### Staff Report & Recommendation

### Design Review Board

SUBJECT: DRB18-0305 (DRB18-0226)  
**100 South Pointe Drive – Continuum on South Beach, South Tower Condominium**

SUBJECT: DRB18-0226

**MASSING STUDY FROM THE OFFICE OF SOM 11-16-98**

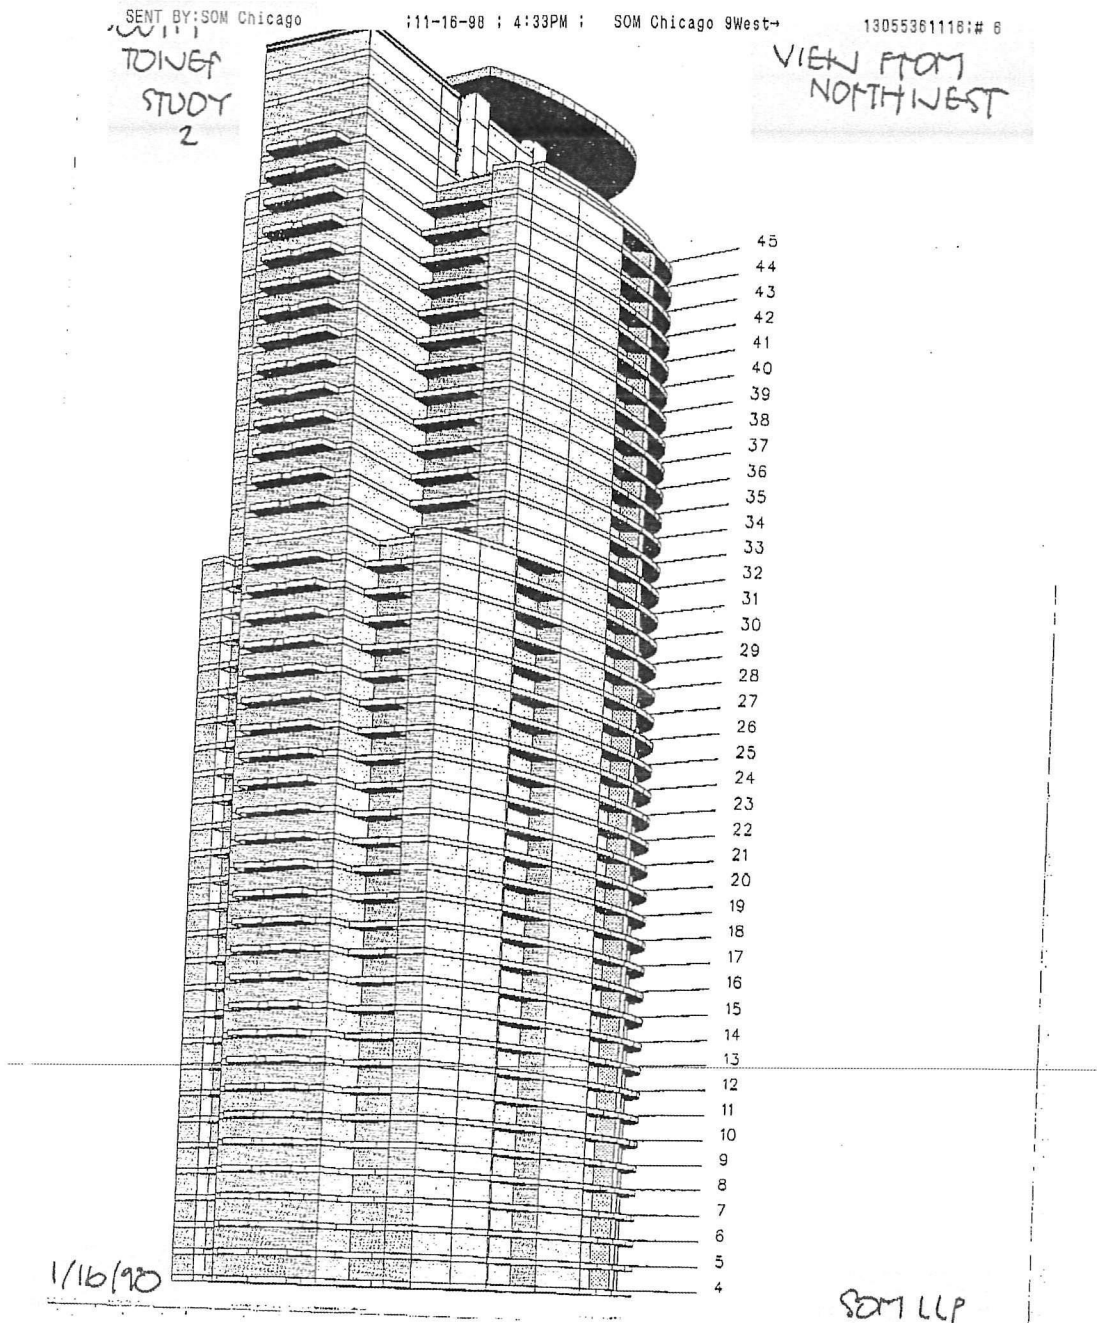
Documentation from the previously approved, original, DRB File No. 9611, 100 South Pointe Drive, includes massing studies and architectural drawings that show thickened balcony

slab ends, to match the horizontal stucco banding that runs along all elevations of the building.

RENDERING FROM THE OFFICE OF SOM

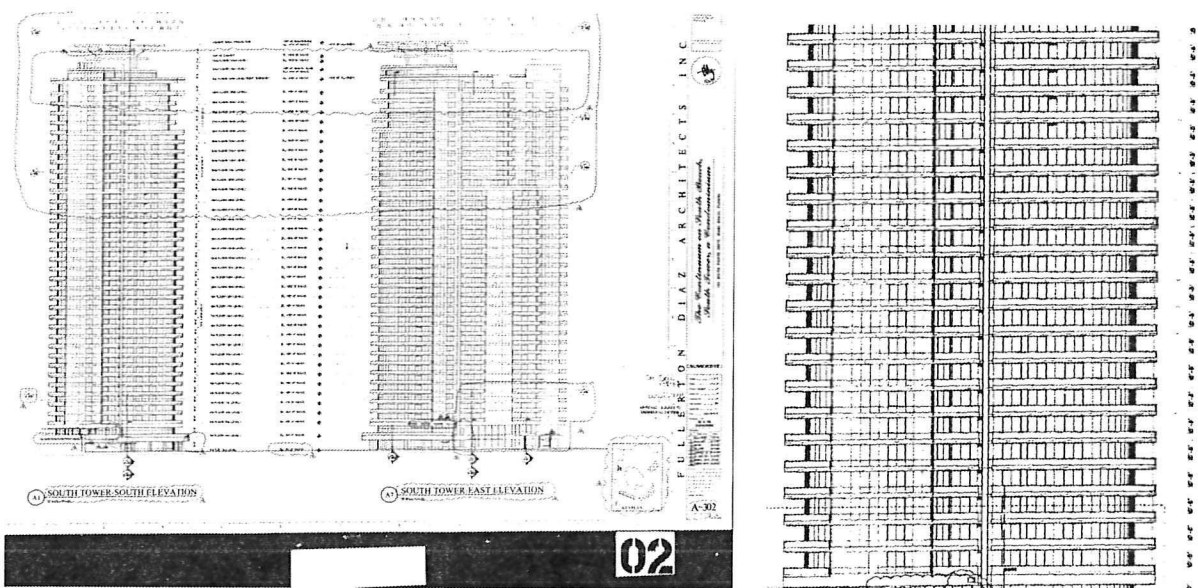
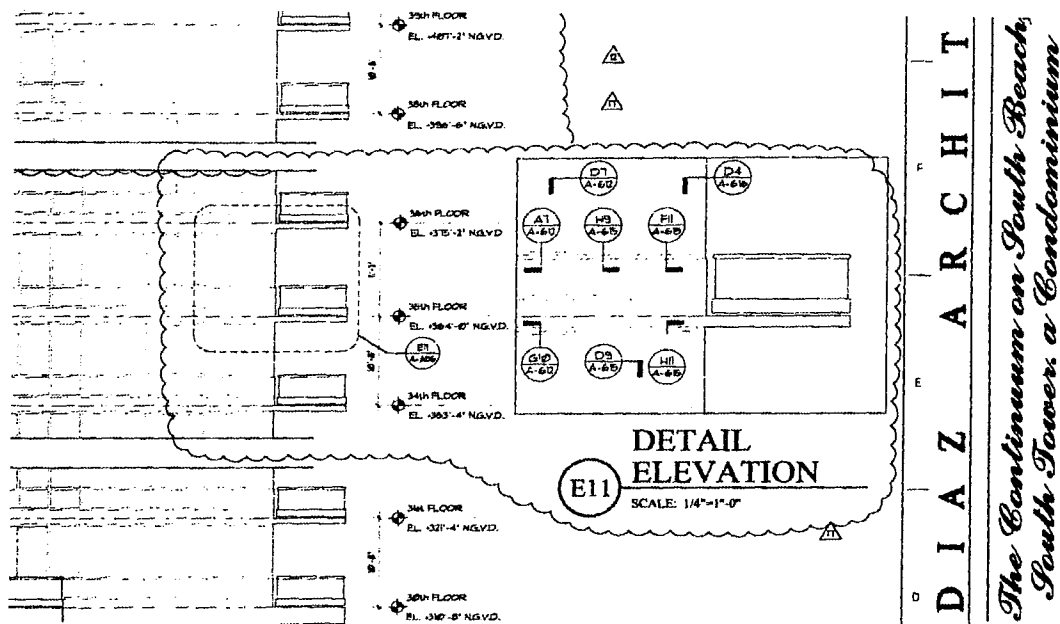
The Design Review Board approved a building design, at a design development stage that depicted thickened balcony slab edges to match the horizontal stucco banding that runs along all elevations of the building. The inclusion of the panels at the time of permit, to

address building and construction requirements, were to ensure compliance with the approved DRB design.
